Application for Licence Amendment

Licence Number	L8469/2010/2
Licence Holder	Galaxy Lithium Australia Limited
ACN	130 182 099
File Number	DER2014/001110-1
Premises	Ravensthorpe Spodumene Project Newdegate - Ravensthorpe Rd RAVENSTHORPE Legal description – Part of Mining Tenement M74/244 As defined by the Premises map and coordinates attached to the Revised Licence
Date of Report	11 February 2022
Decision	Revised licence granted

Figure 3: Perspective view of the 2SE in-pit TSF showing embankment height.

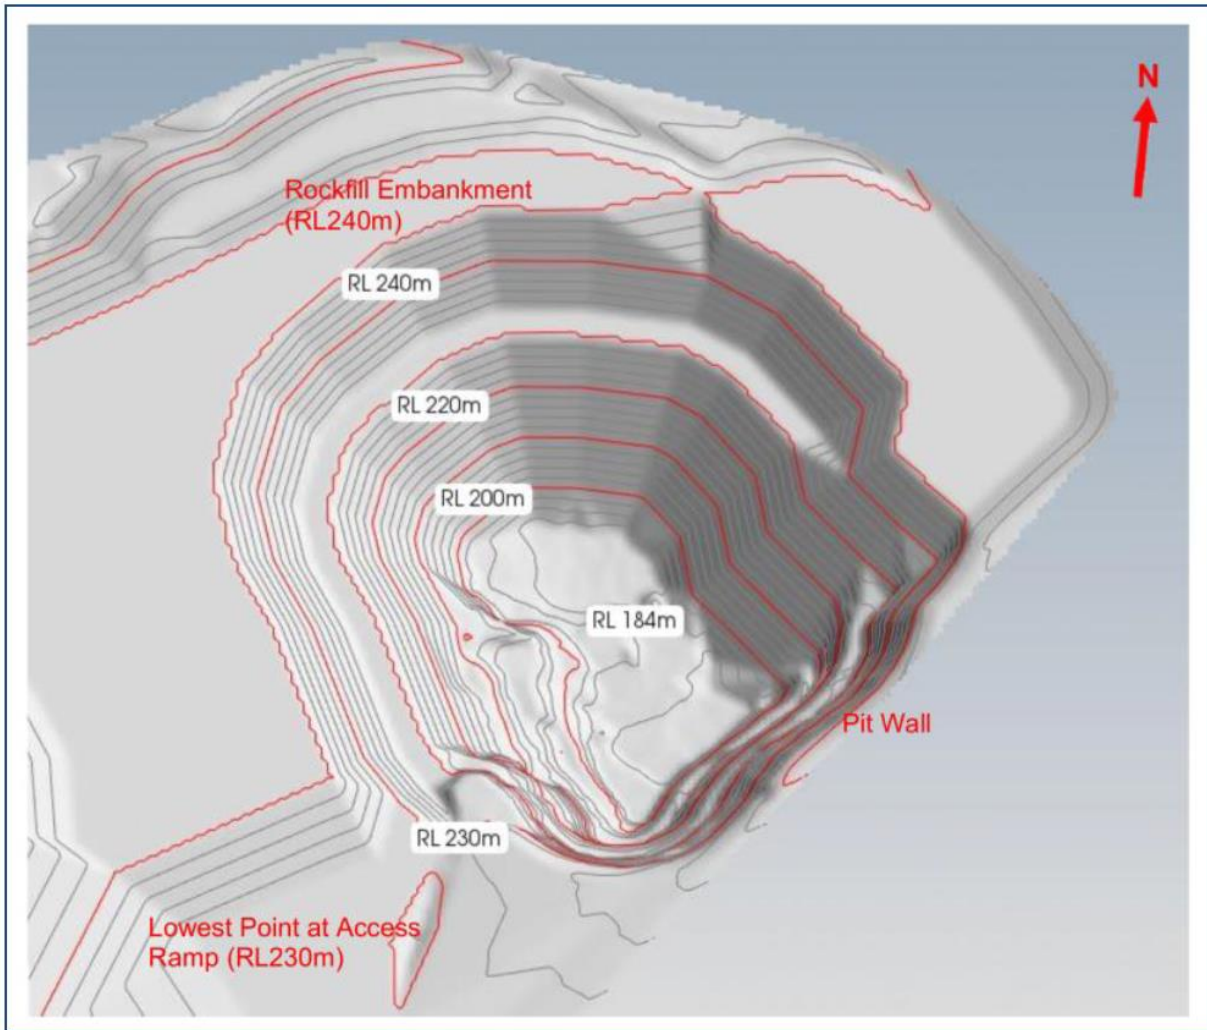
The rockfill embankment aligns the northern and western side of the pit and is constructed to a maximum crest elevation of RL240m using fresh mine waste rock. The lowest elevation within this embankment is an access ramp at RL230m (see Figure 3).

The tailings slurry will be deposited into the 2SE in-pit TSF at 40-50% solids. Tailings deposition will be through a single spigot discharge. The maximum storage capacity of the proposed in-pit TSF is approximately 790,000 m³ which is equivalent to approximately 1.185 million tonnes (Mt) or a storage life of approximately 2.8 years. The maximum storage capacity is defined by the RL230 m, allowing for a minimum freeboard of 500 mm.
